June 22, 2012

Subject: Request for Change to License Technical Specifications Incorporating 2008,
2010, and 2011 Requests

Appendix A
DRAFT Technical Specifications
Revision 2
Docket 50-602
The University of Texas at Austin
TRIGA Reactor
JUNE 2012

Figure A.3.1.1-1, Xenon Concentration Following Shutdown (Linear Scale)

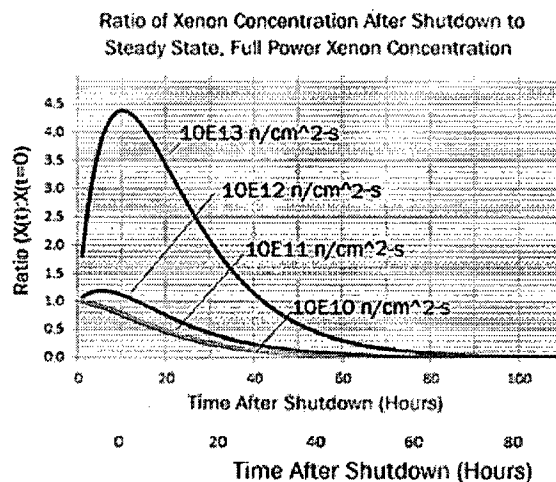
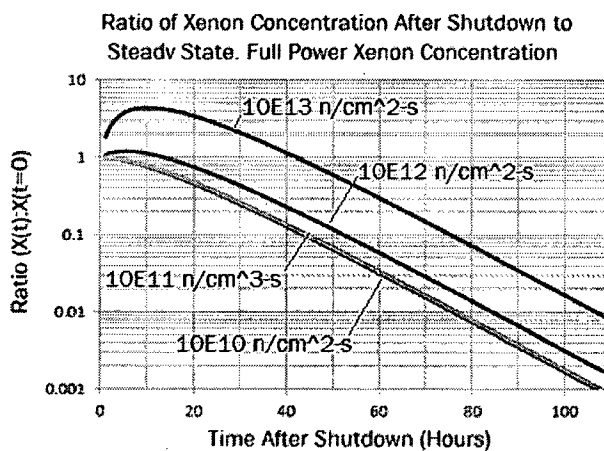
Calculations show that reactivity change from xenon following shutdown from full power equilibrium conditions cannot be detected using control rod positions after 72 hours, where the reactivity from xenon is less than the β_{eff} (which experience shows is a minimum detectable level based on a single control rod differential position). Therefore, a more conservative approach is proposed where the reference core condition is restricted to conditions where reactivity from xenon is below the level that would occur 72 hours after shutdown. This may be verified in determining the reference core condition by allowing a 72 shutdown hour interval or by calculation when desired (for instance, when the reactor has not achieved equilibrium conditions prior to shutdown).

The specification has been revised to reflect this proposed requirement, and supporting analysis has been completed and incorporated in a revision to the basis for section 3.1.

- A.3.1 – Analysis of xenon transients to justify limits on reactivity from xenon when determining reference core conditions.
- A.3.1.2 – Incorporation of the restriction on using experiments to credit shutdown margin.
